Service Letter No. 328

SUBJECT: Lycoming Service Letter No. L126 dated January 29, 1960

SUBJECT: Conversion to Low Compression Engine

SUBJECT: Replacement of Guide Collars with New Forged Collars on Certain Non-Feathering Flange Mounted Propellers.

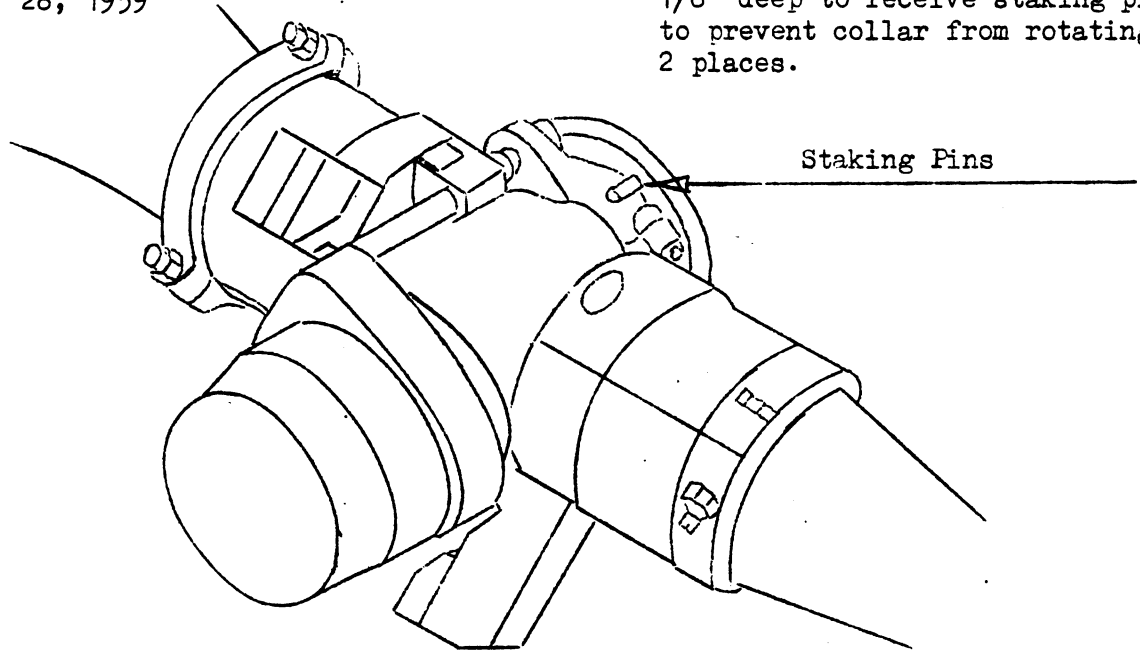
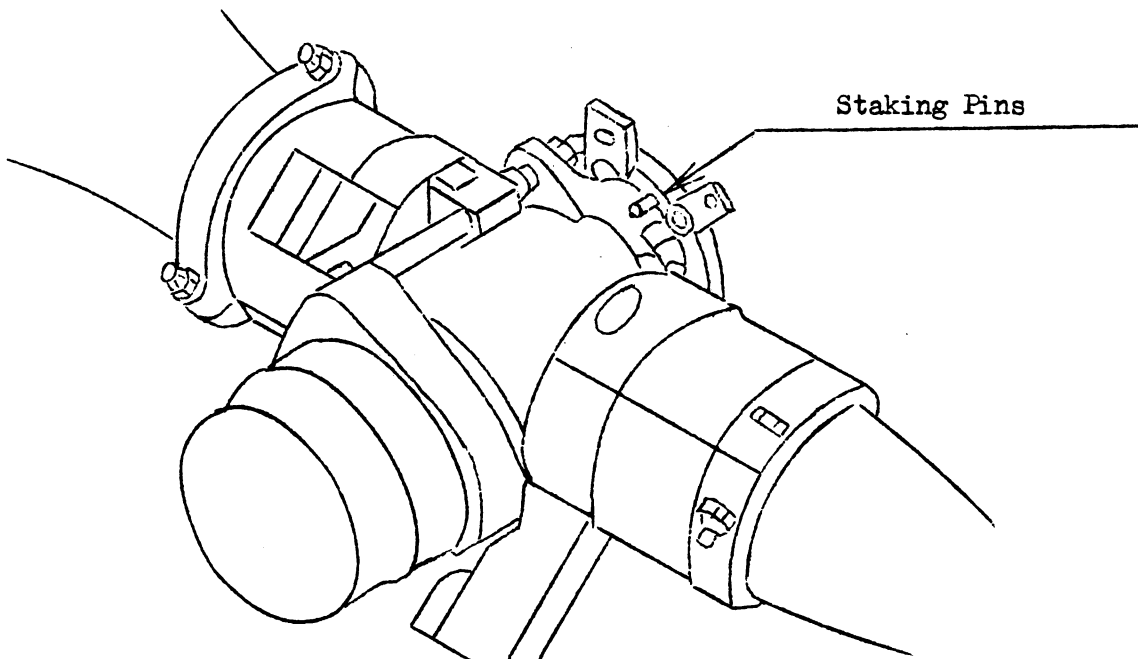
Replace the cast guide collar on these models affected by this bulletin with a forged collar as soon as convenient but not later than the next overhaul or January 1, 1961, whichever occurs first. Until the forged collar is installed, frequent visual inspections of the part is recommended. This can be done without removing the spinner, by looking through the spinner blade cut-outs. The cast parts which have been physically tested need not be inspected or replaced. These collars are marked with the letter "P". Forged collars are marked with the letter "F".

When the new collar is installed, it will be necessary to spot face the edge of the new guide collar thru the two dowel pin holes and reinstall the dowel pins as shown on Page 3.

After collar is properly located to receive piston guide rods, spot face edge of collar, approx. 1/8" deep to receive staking pins to prevent collar from rotating, 2 places.

First, install 4 spinner lugs, using new AN4E-4A bolts. After collar is properly located to receive piston guide rods, spot face edge of collar approximately 3/32" deep to receive staking pins to prevent collar from rotating, 2 places.

CAUTION!!! - For Model HC-82XF-1DB, the two steel dowel pins inserted in both the engine and propeller flanges are located 60° from the aluminum staking pins shown. BE SURE TO REPLACE THESE PINS. For the other models, the dowel pins also serve as collar staking pins.

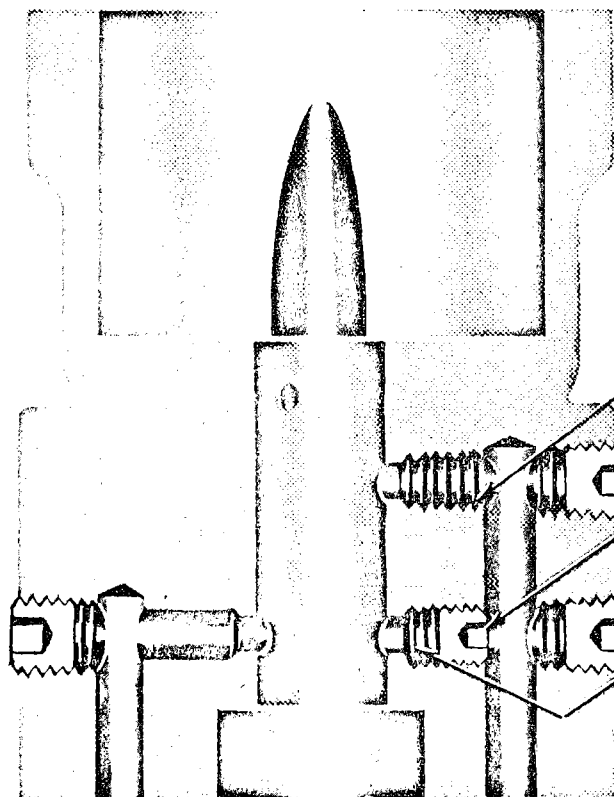
Governor body modification for changing propeller control pressure from decrease pitch to increase pitch.

All controls that have plug in upper passage, see below, supply propeller control oil to decrease pitch. In the event a change in propellers is made and the new propeller requires control pressure to increase pitch, the governor bodies should be reworked per instructions shown below.

REMOVE PLUG
187824 FROM TOP
HOLE AND

INSTALL IN
BOTTOM HOLE

TAP $\frac{1}{16}$ -27 NPTF
(DRYSEAL)

BASIC GAGE LINE
TO BE .720 FROM
THIS SURFACE.
0 TO PLUS 2
TURNS FROM BASIC.

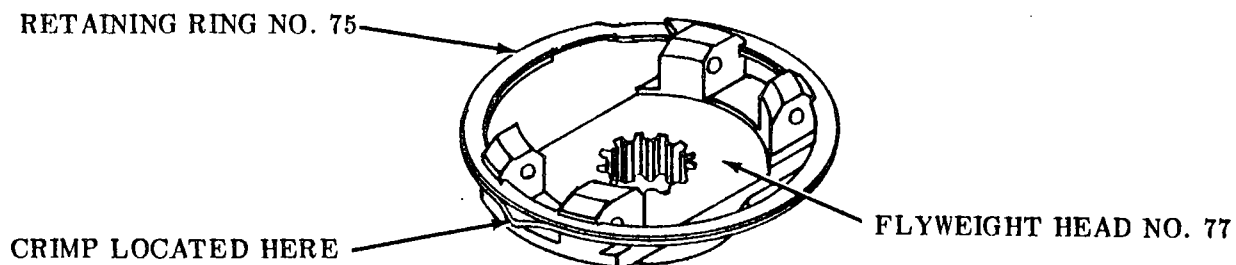
SUBJECT Proper installation of flyweight retaining ring (75), with the crimp down, in all CSSA and CSDA model governors.

PURPOSE To describe the proper installation of the flyweight retaining ring. Torsional vibration from the engine to the governor drive tends to cause relative rotation between the flyweight head (77) and the retaining ring (75). If the crimped leaf of the retaining ring climbs the chamfer on the lug of the flyweight head, the crimp will no longer be positively retained between the flyweight head lugs, and the retaining ring may be rotated out of the retaining ring groove. Removal of the retaining ring from the flyweight head releases the flyweight pins which causes the governor to be non-controlling, in addition to causing internal damage to the flyweight cavity of the governor body. Installation of the retaining ring, with the crimp down, prevents the crimped leaf from climbing out of the groove on the flyweight head lug.

DETAILS Retaining ring (75) must be installed on the flyweight head with the crimp of the retaining ring toward the thrust bearing surface and between the flyweight lugs as shown in Figure No. 1. Be sure that the retaining ring is properly seated in the groove. ALL GOVERNORS SO MODIFIED MUST BE STAMPED WITH S22 ON THE GOVERNOR NAMEPLATE.
